NAGRA VI SERVICE BULLETIN

To use an external keyboard or other equipment on the host USB, 3 pull up resistors need to be added on the digital unit PCB. 9132 220 000.

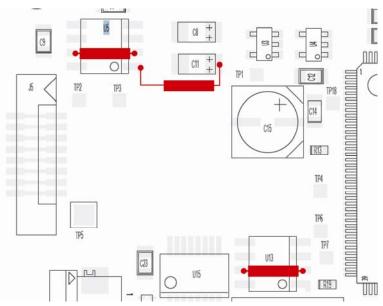
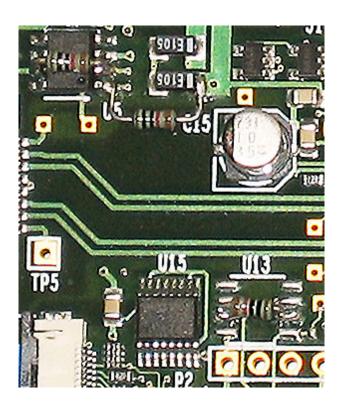
See the pictures concerning the position of the 3 resistors.

Add a resistor of 10 k Ω :

Between pin 2 & 7 of U5 Between pin 2 & 7 of U13 Between U5 pin 1 and C11 pin +.

10 kΩ ¼ Watt Part number: 5527182103
